Amendment to the Drawing

A replacement formal drawing is submitted consisting of FIGs 1, 2, 3, 4A, 4B, 4C, 5, 6A, and 6B on 9 sheets.

An amendment to the title is requested, replacing the title as filed in the subject application ("Hand-Held Stun Gun For Incapacitating A Human Target") with "Less Lethal Weapons And Methods For Halting Locomotion".

FIG. 6A

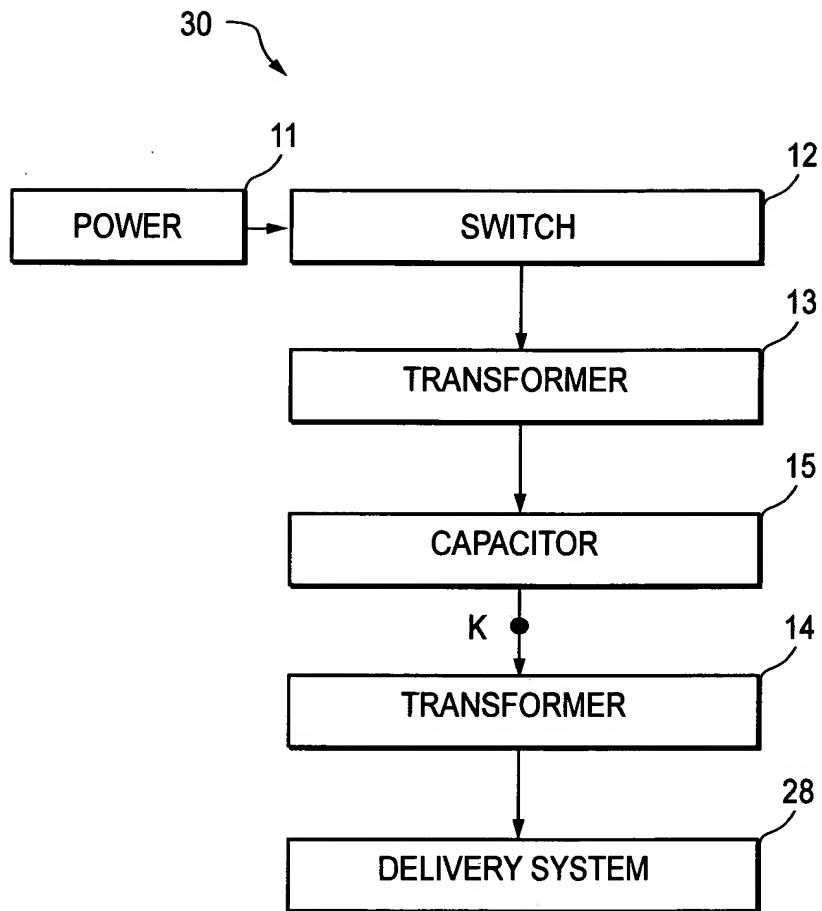
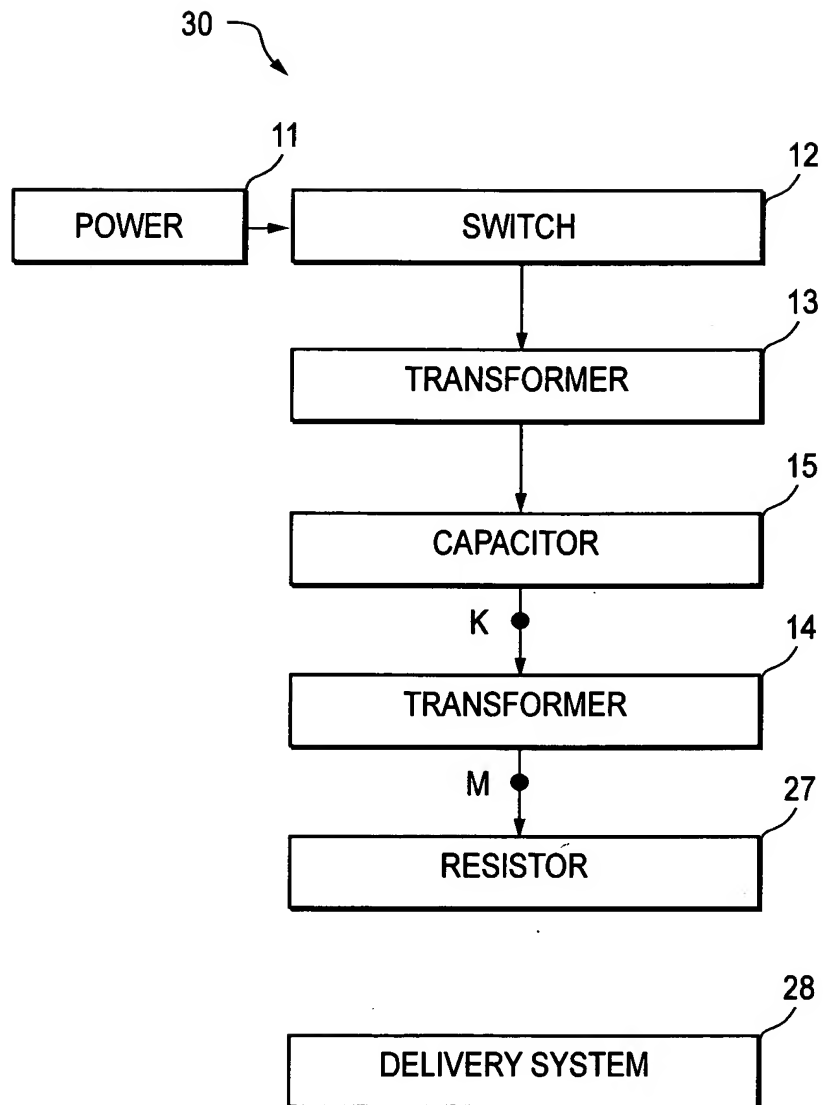
FIGs. 6A and 6B aid in understanding paragraphs [0052] through [0054] of the marked up version of the substitute specification. These paragraphs admit a drawing. No new matter is submitted.
